SUBJECT: Forwards responses to Structural Engineering Branch questions on masonry walls to close SER Outstanding Issue 13. Justification for use of average response spectra typical wall fix diagrams also encl.

SUSQUEHANNA STEAM ELECTRIC STATION
SER OUTSTANDING ISSUE 13
ER 100450 FILE 841-2
PLA-760

SUSQUEHANNA SES UNIT 1 AND 2
DOCKET NUMBERS 50-387 AND 50-388
CATEGORY I MASONRY WALLS

FIGURE NO. 1

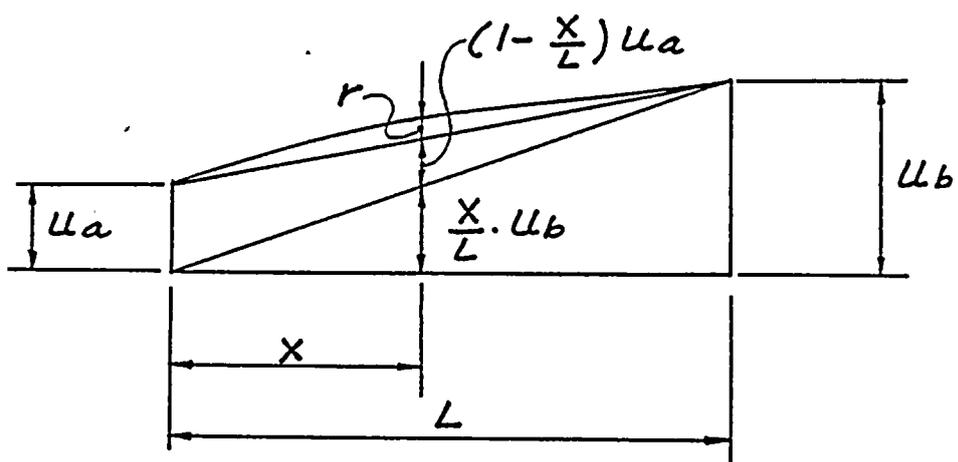
In your response to Question 4: (1) It is indicated that response spectrum method is used for the dynamic analysis of the concrete masonry walls. However, there is no mention as to which of the response spectra is used, upper floor or lower floor response spectrum or the average of the two. It is required that an upper bound envelope of the individual floor is used. (2) Though the use of ACI 318 formula the cracking of concrete masonry wall is considered. The use of such a formula is questionable in view of the fact that in a concrete masonry wall the weakest section is the bed joint and the modulus of rupture is equal to that of neither the concrete block nor the mortar. Indicate how the modulus of rupture is established in your computation.

The evaluations herein demonstrate that: (1) The use of the average floor acceleration response spectra to calculate the response of the wall panel is appropriate, and (2) The use of uniform inertia load with magnitude equal to the average spectral acceleration for the fundamental mode, in calculating the maximum seismic responses is a good approximation, even considering the higher mode effect.

For the purposes of this evaluation, the seismic response of a simply-supported, uniform beam simulating a strip of the wall panel with unit width is considered, as shown in Figure 1.

TYPE 1
ANGLE BRACING TO CONCRETE

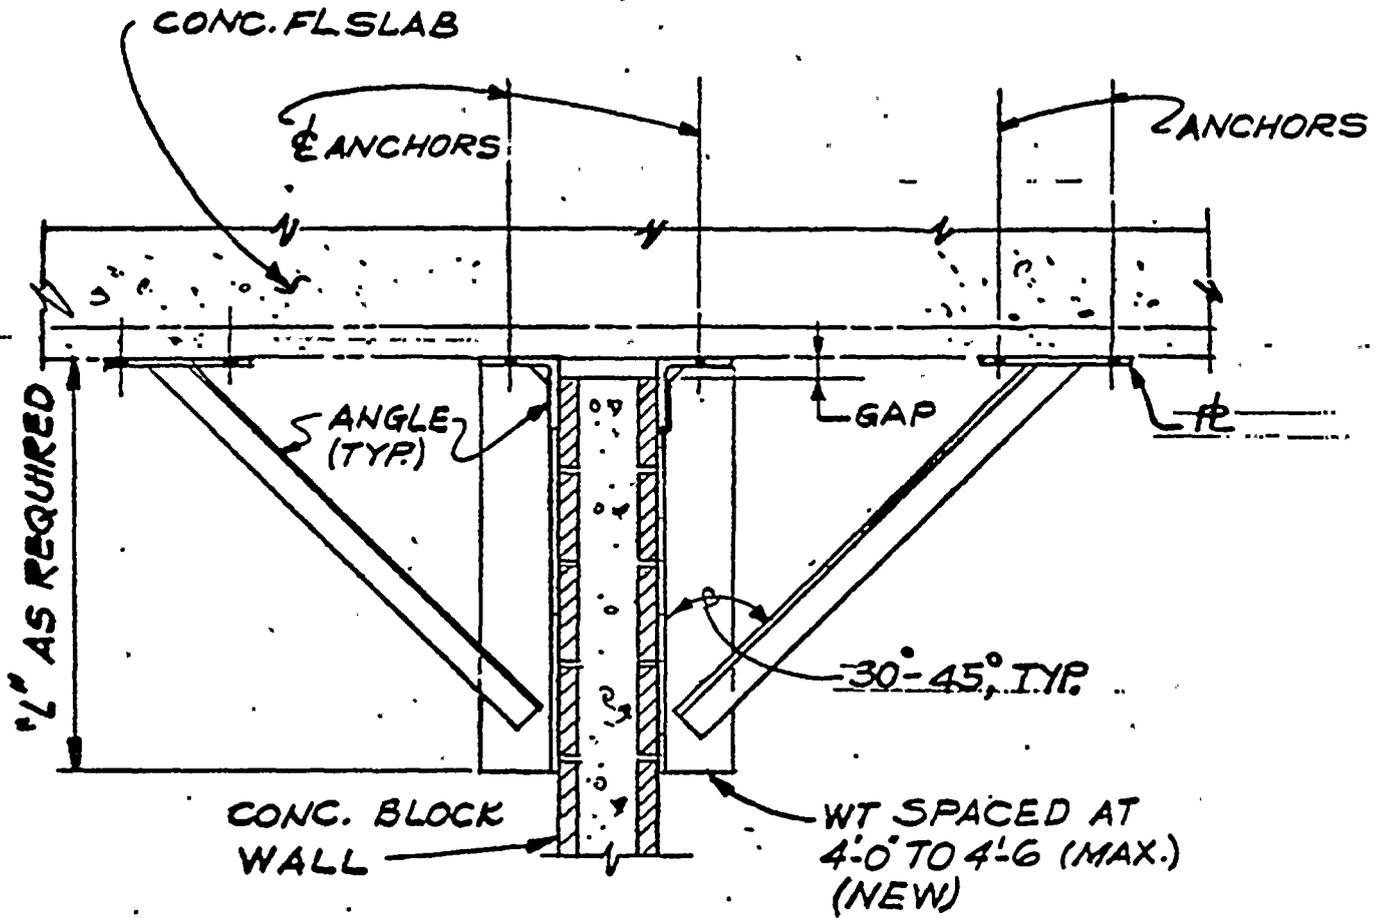
In response to Question 5, it is stated that when the design stresses of masonry walls exceed the allowable stresses, fixes are designed such that the criteria is satisfied. Indicate the number of walls where such fixes are needed and provide examples.

The number of masonry walls requiring fixes for cracked section criteria is 36. Wall location, thickness, and elevation are as shown in Table 2. Typical fixes are shown in details type 1, type 2, type 3, and type 4 (see Enclosure 2).
